Dresden 2 and 3

**Technical Evaluation Report
on the Individual Plant Examination
Front End Analysis**

NRC-04-91-066, Task 19

Science and Engineering Associates, Inc.

Figure 2-1. Comparison of Data for Recovery of Offsite Power

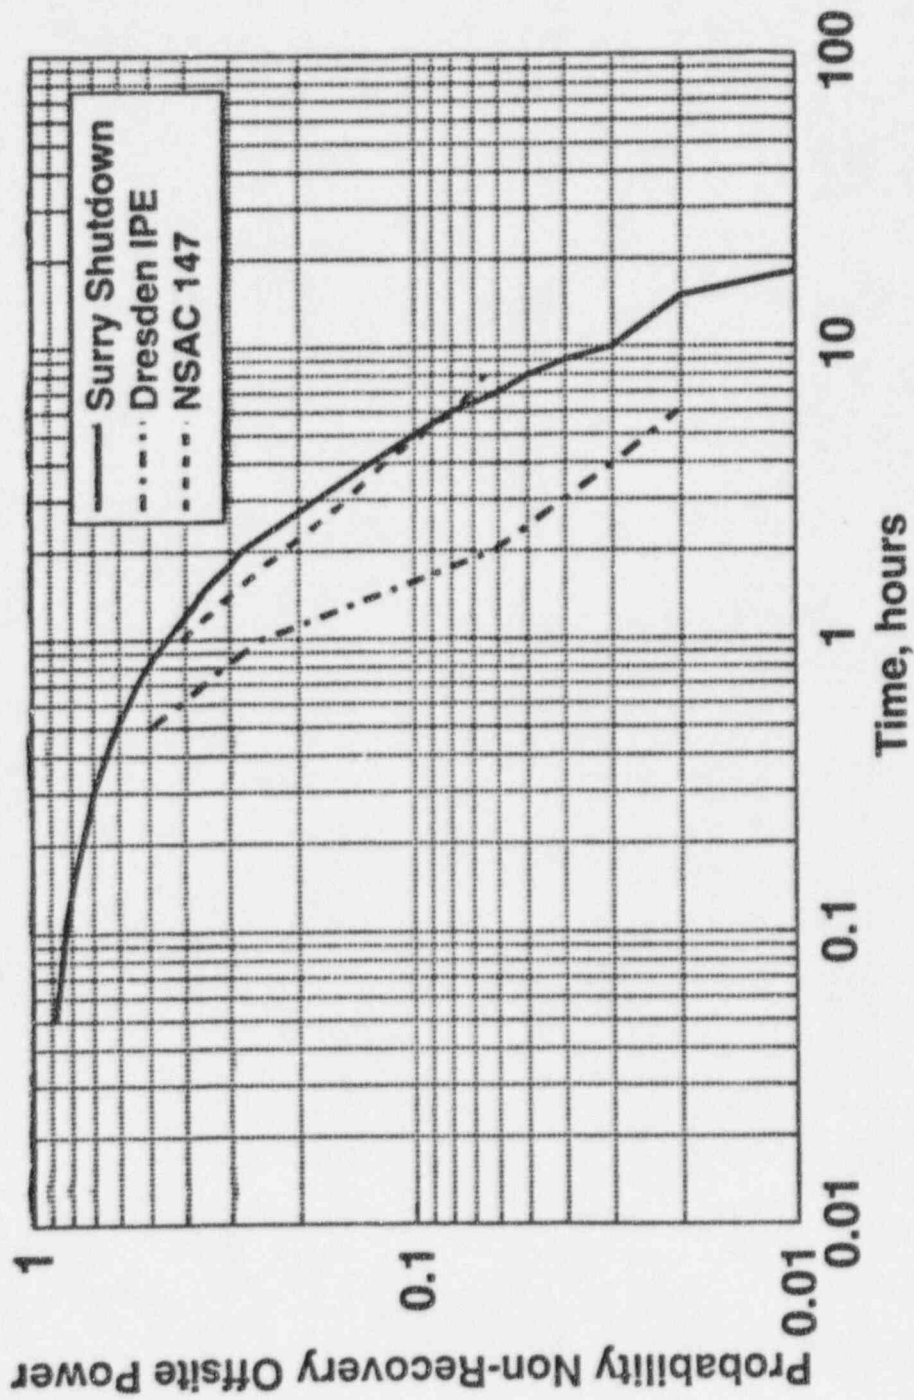
Another factor that reduces the contribution of station blackout to overall CDF is the relatively low probability used for non-recovery of offsite power within 4 hours. As indicated in the listing of sequences in Table 4.5.3-1 and in the data of Table 4.5.2-1, the probability of non-recovery of offsite power within 4 hours was taken as 0.0205; this is about a factor of 6 lower than the probability used in many PRA/IPEs. [NUREG/CR 6144] [NSAC-147] Figure 2-1 of this report compares the data used for non-recovery of offsite power in the Dresden IPE to typical data. For comparison purposes, the Nine Mile Point 1 IPE used a probability for non-recovery of offsite power of 0.07 at 4 hours. [TER Nine Mile Point 1] The licensee provided the values given in Table 2-5 of this report: [TER, Quad Cities]

Note that the probability of non-recovery by 4 hours used in the Quad Cities IPE is 0.067, a factor of 3.3 higher than that used in the Dresden IPE. Compared to typical data used, the data used in the Dresden IPE for recovery of offsite power results in a lower CDF from station blackout by about a factor of 3 to 6.
